Nebraska Public Power District

July 10, 1978

Subject: Movement of Heavy Loads Near the Spent Fuel Facility -
Request for Information
Cooper Nuclear Station
NRC Docket No. 50-298, DPR-46

HORIZONTAL CONTROLLED PATH OF SPENT FUEL CASK

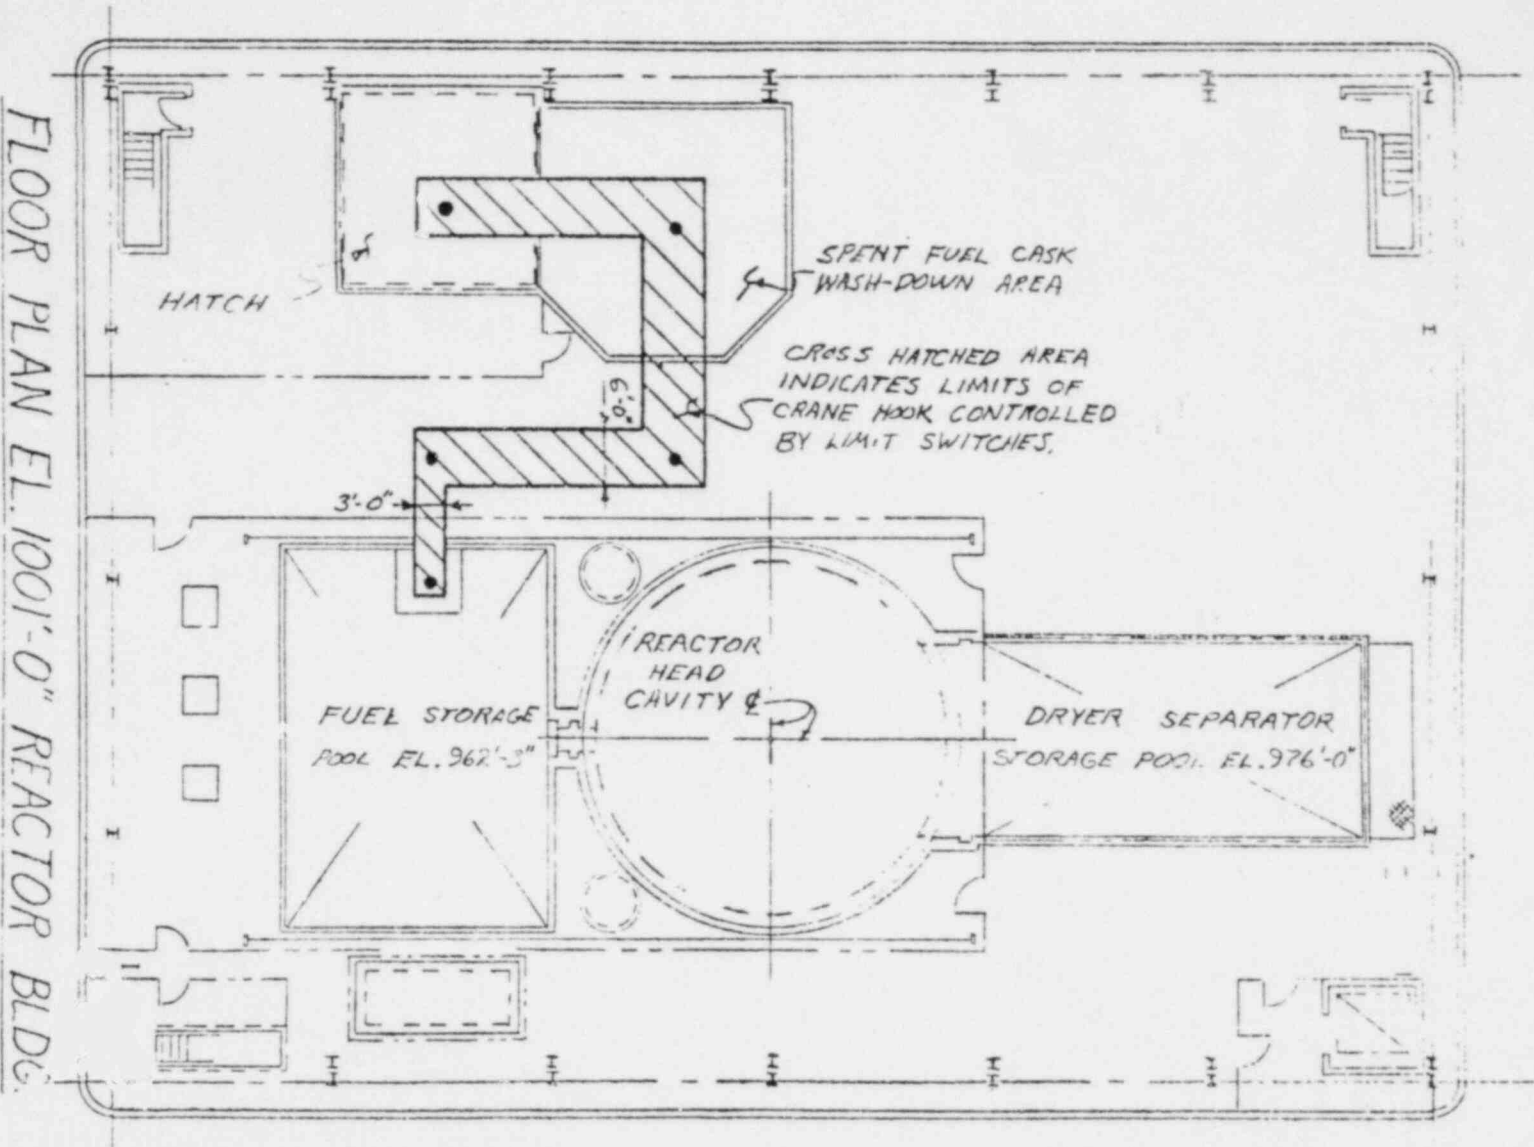
- c. When the crane selector switch is on the "restricted" mode the crane can only be operated within the predetermined restricted boundary. A diagram of the path of restricted movement is included in FSAR Amendment 33. With the crane selector switch on "normal", the crane can be operated throughout the refueling floor.

ALL CASK HANDLING ABOVE THE 931' LEVEL OF THE REACTOR BUILDING WILL BE DONE IN THE "RESTRICTED MODE" WHICH WILL CONFINE MOVEMENT TO THE CASK CONTROLLED PATH AS SHOWN IN ATTACHMENT "A".
